Re: 121-129 York Street, Harborview Townhouses  
Final Site Plan Application  
Request for Reconsideration

TITLE:  
**EXHIBIT A.**  
DIMENSIONED PARKING PLAN  
(NOT FOR CONSTRUCTION)

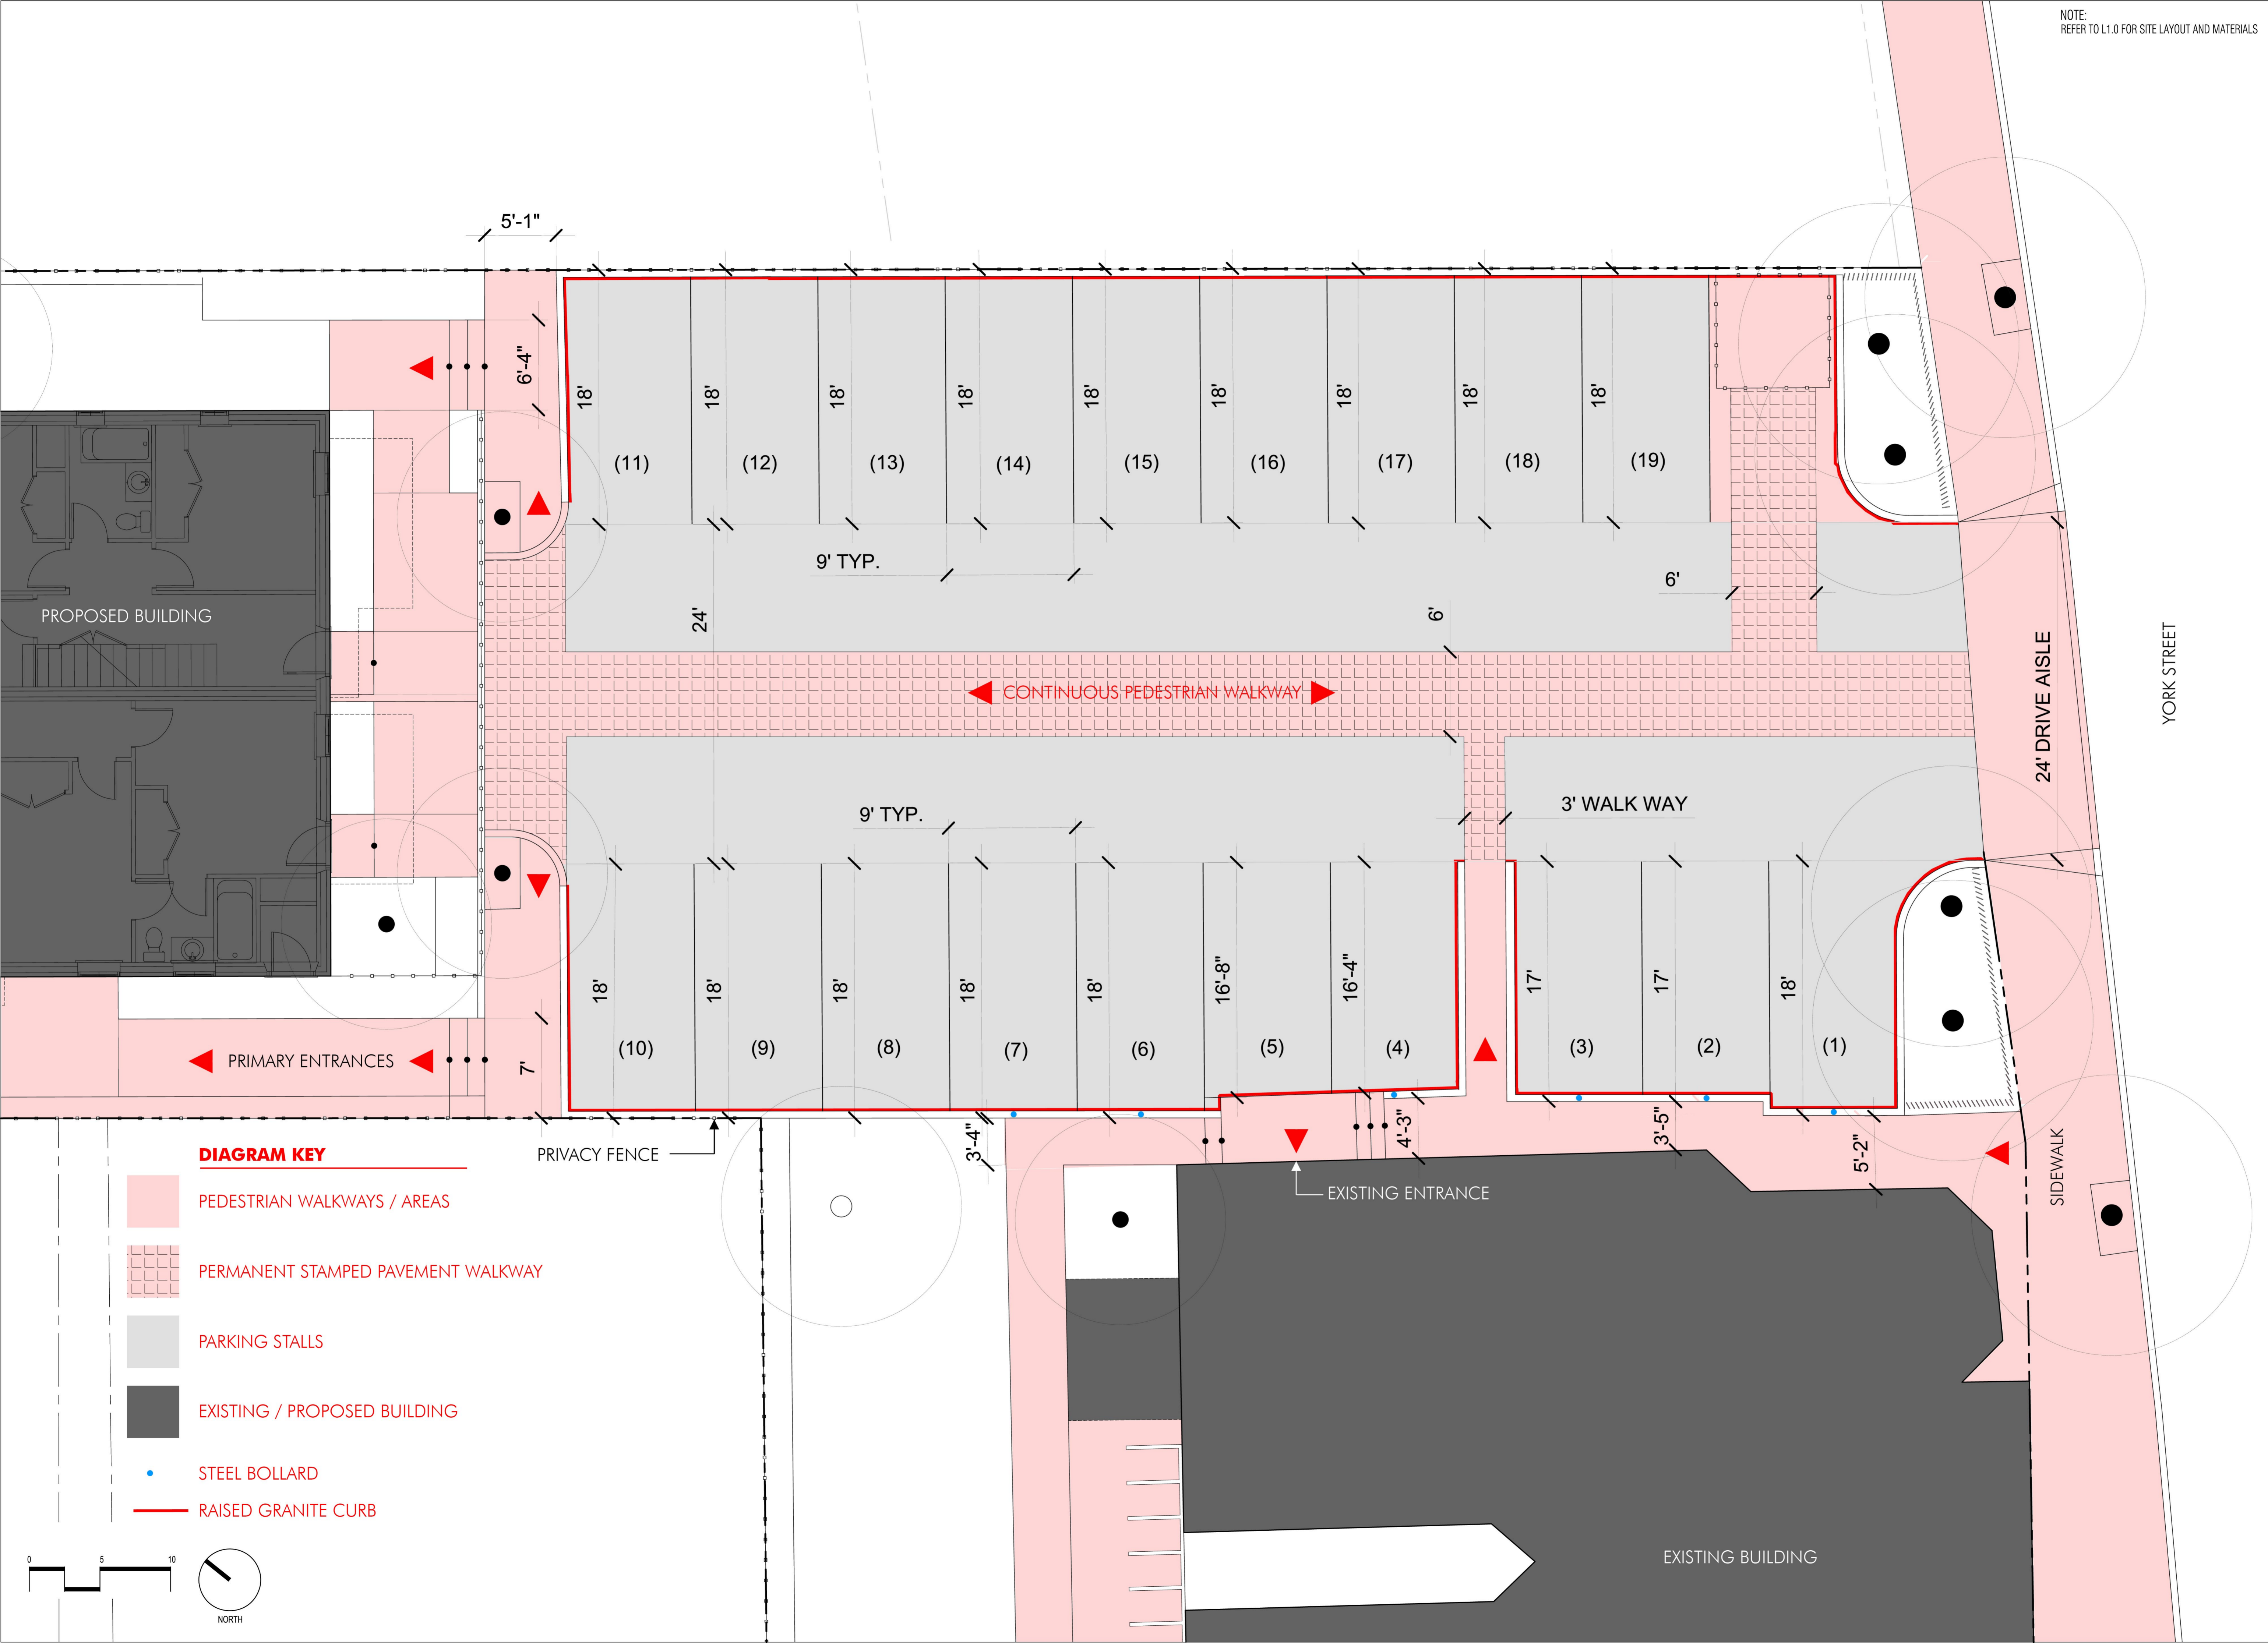
Additionally, we are seeking a waiver for one substandard parking space, above that which is allowed. Exhibit A to this letters shows that of 19 parking spaces, 15 are standard size (9' x 18'), while 4 are only slightly substandard. The substandard spaces are: 2 spaces at 9' x 17' (spaces #2 and #3), 1 space at 9' x 16'8" (space #5) and 1 space at 16'4" (space #4). A compact space is considered 8' x 15', so these substandard spaces are significantly larger than the minimum dimensions for compact parking. However,

We believe that our current plan meets the standard. Exhibit A shows a continuous internal walkway. While it is not a dedicated sidewalk, 14-526 (a)(2)(c)(iii) does not require “dedicated” access, nor does it refer to a “sidewalk”.

The walkway in Exhibit A starts on the sidewalk of York Street and extends roughly 35 feet west toward the new building. Along this stretch, steel bollards will be installed to prevent cars from overhanging the walkway. Next, the walkway, protected by curbing turns right and heads toward the drive aisle. At the center of the drive aisle, the walkway is 6’ wide and turns west and continues all the way to the proposed building. While in the drive aisle, the pedestrian walkway is differentiated by permanent stamped paving.
